Interactive comment on “Quantification and mitigation of the impact of scene inhomogeneity on Sentinel-4 UVN UV-VIS retrievals” by S. Noël et al.

Reply to referee 1

Fig. 1. Normalised spatial response function for the UV-VIS in east-west direction in ground coordinates. Red: Without scan. Green: With scan.

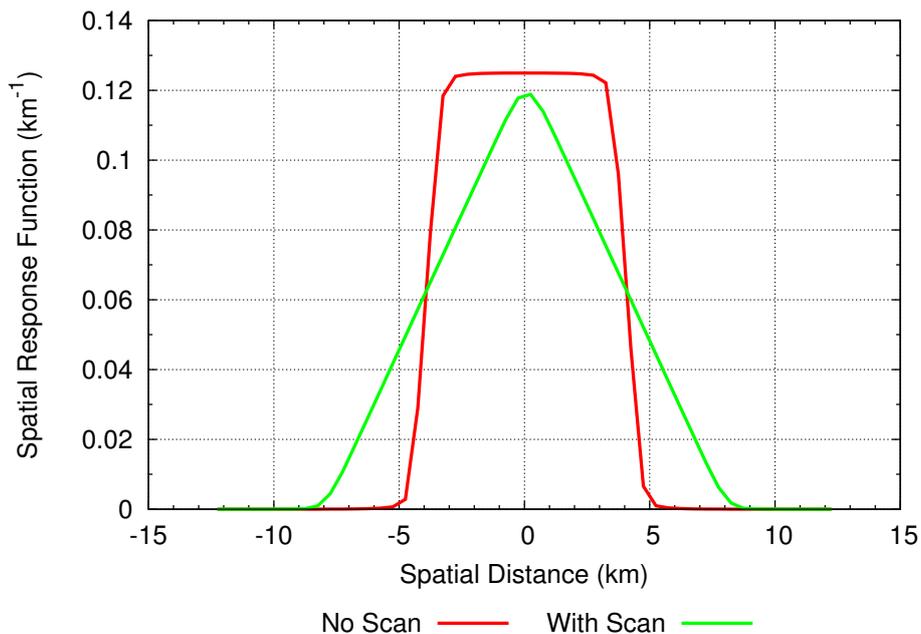
3. *Page 2046, lines 5-12: Explain in more detail what the UVN instantaneous field of view is, how it scans from east to west over 8 km in about 6 seconds and what the convolution of the 2 looks like, since this is important to understand the impact of scene inhomogeneity of instrument spectral response.*

The typical UVN ground sample size is 8 km × 8 km. The spatial response function of the UVN instrument in east-west direction is shown in Fig. 1, giving the sensitivity of the instrument to light coming from different directions / spatial distances relative to the centre of the observed scene. As can be seen from this figure, the spatial response function is in the UV-VIS of trapezoidal (almost rectangular) shape with a full width at half maximum (FWHM) of about 8 km. During one integration time (about 6 s) the instantaneous field of view (IFOV) is moved about 8 km from the east to the west by the scan. By this the spatial response function is smeared, resulting in an almost triangular shape (but with similar FWHM).

This is added to the manuscript appropriately.
